Historic Preservation Services

CERTIFICATE OF APPROPRIATENESS

As you are aware, at is March 17, 2021 meeting, the Historic Preservation Commission (then named the Landmark Preservation Commission) provided after-the-fact Final Design Review for several work items at the Long Apartments at 220 E. Laurel Street, a designated Fort Collins Landmark.

A2.1
WORKOUT ROOM PLANS

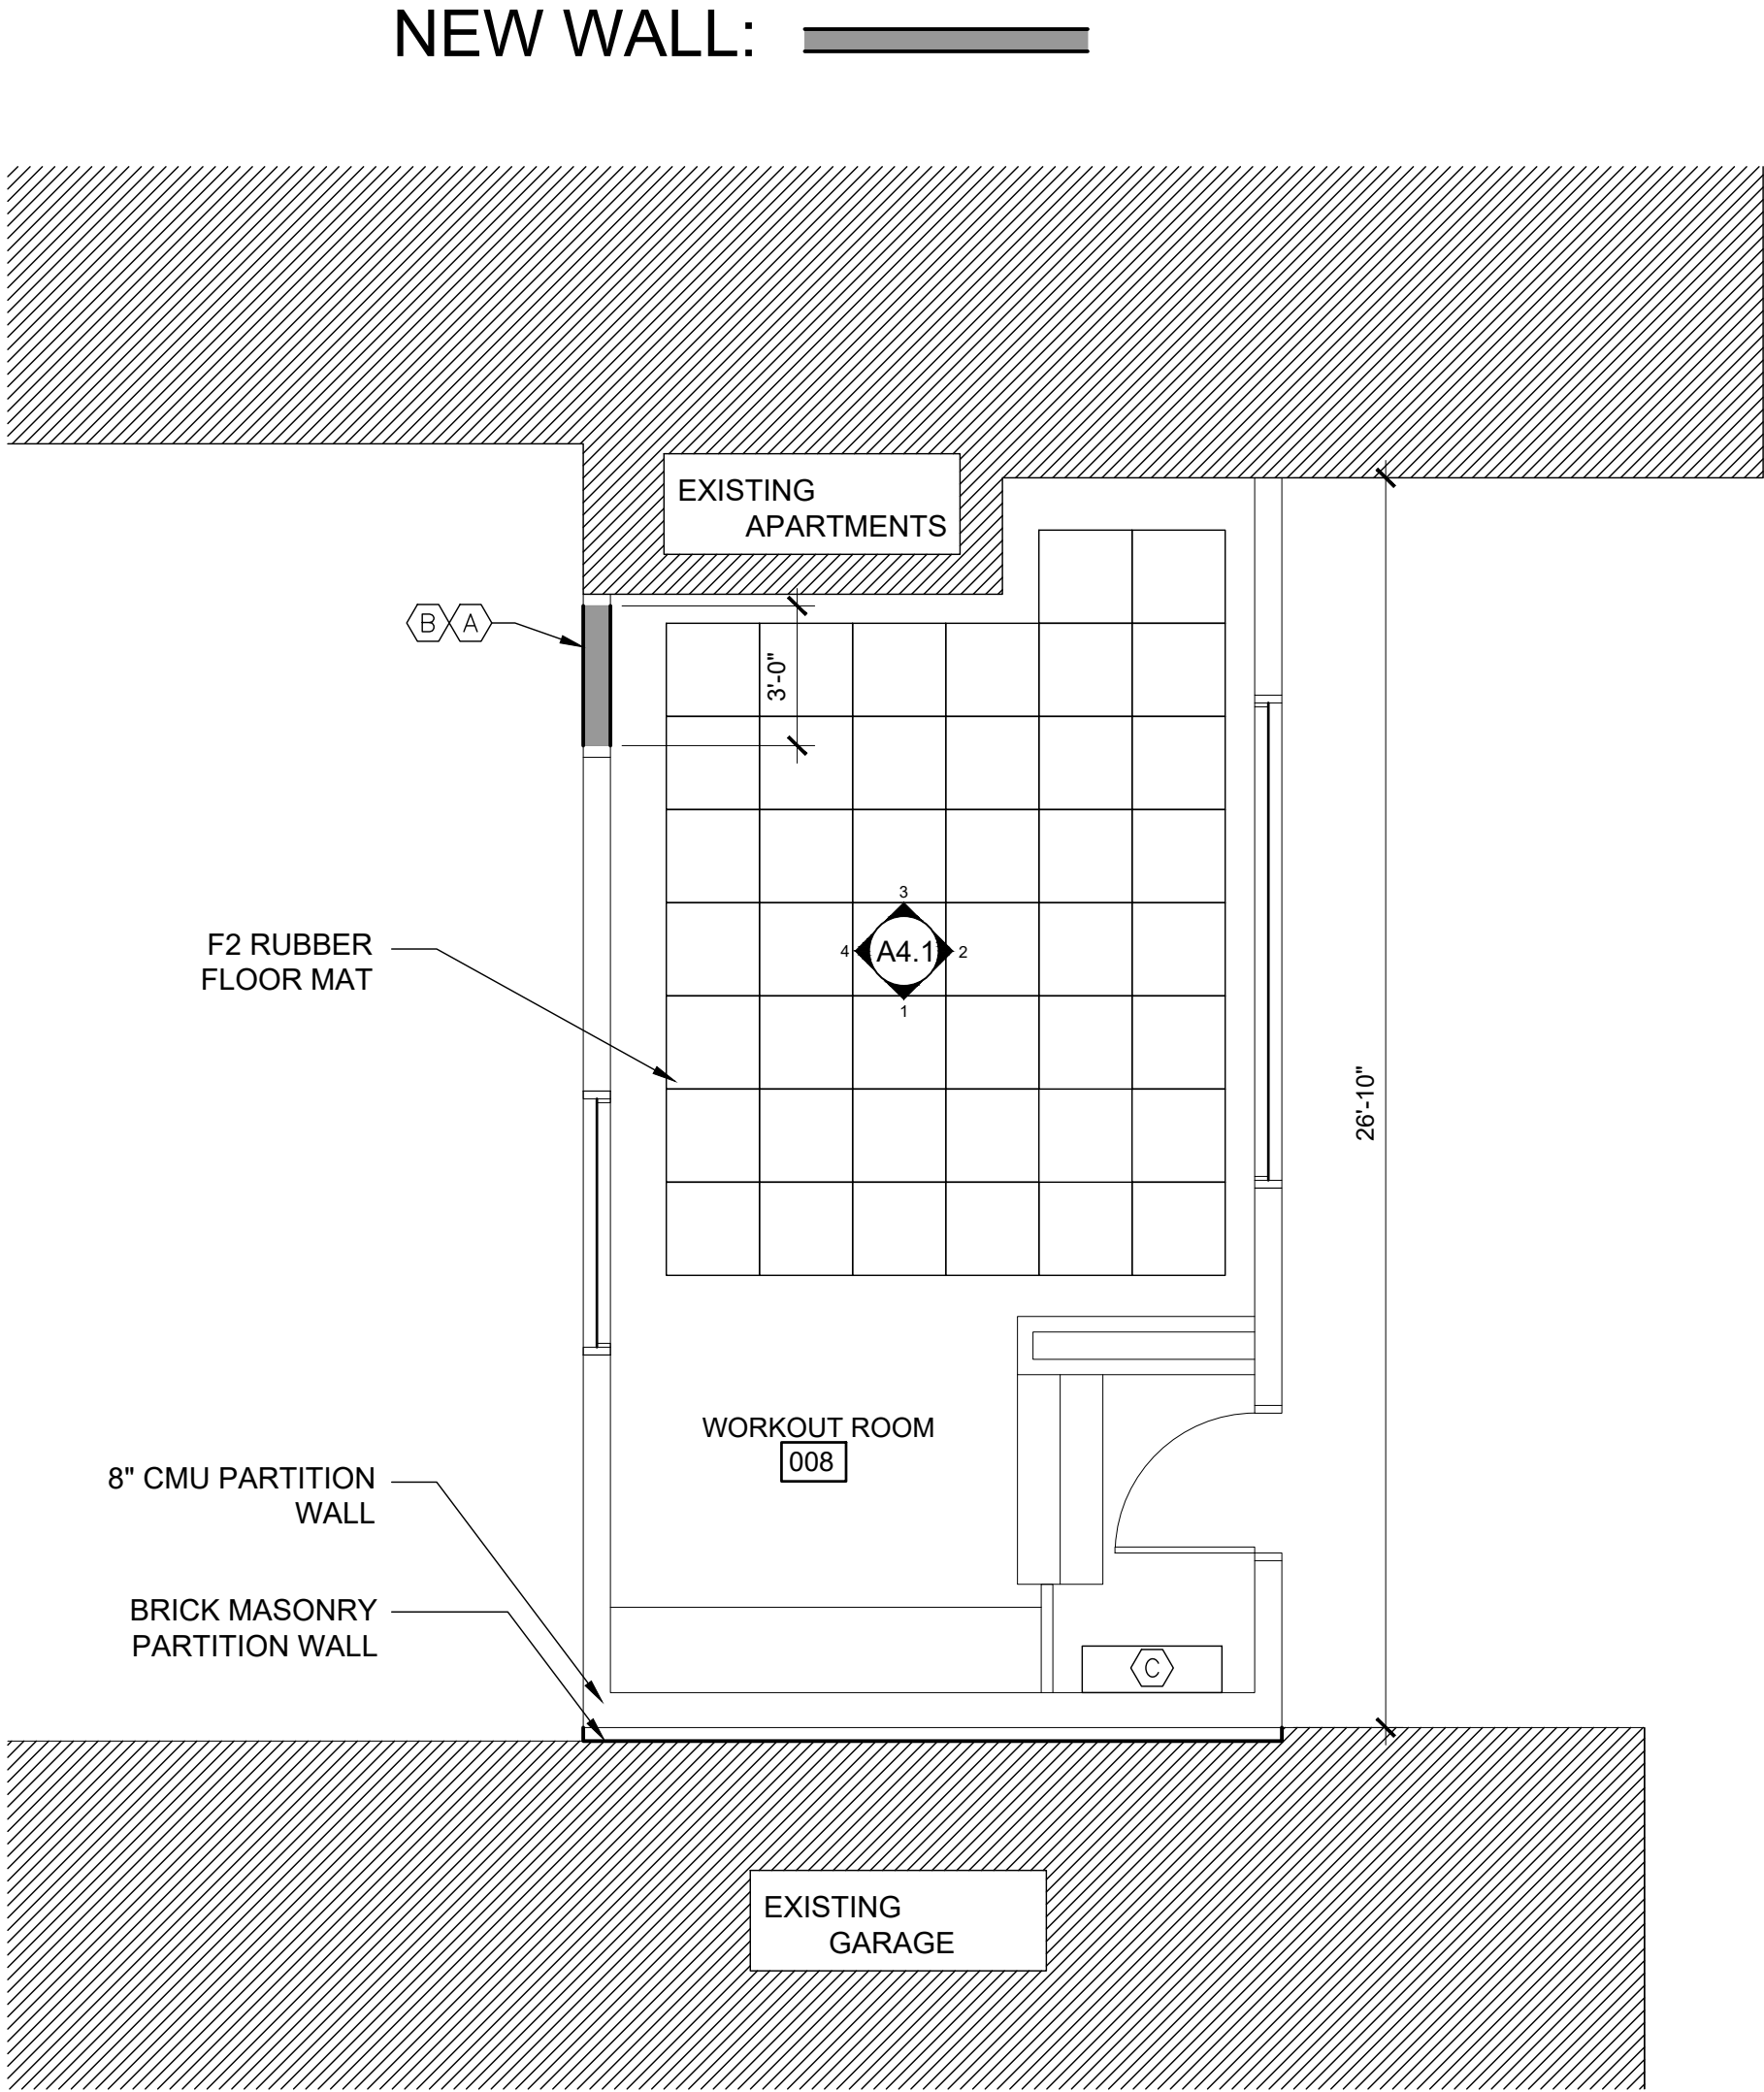
1. Removing a historic access door and filling in the opening on the north (rear) elevation of the c.1951 addition.
 - a. Action required: Reversal to re-establish opening and historic door.
2. Alteration of front stoop tile.
 - a. Action required: New dimensions based on IEBC code requirements may stand but tile cladding must be reversed based on historic photographs.

- A door was filled in with concrete block on the back of the one-story addition. Could you also take a look at that and give us your professional opinion on reversing the infill and re-installing the doorframe back as it was historically? For reference, the door frame was the same as the addition's front door.
- Also, a couple of condensers and different mechanical equipment/conduit were install on the back of the apartment building itself, and on the rear of the addition (see photo).
- And, by the front door, some hardware was added (see photo)

- Ⓐ NEW WALL LOCATION.
Ⓑ FILL IN OLD DOOR OPENING WITH MATCHING INTERIOR AND EXTERIOR MATERIALS. VERIFY MATERIALS ON SITE.
Ⓒ M6 LOCKERS. REFER TO SPEC SHEET
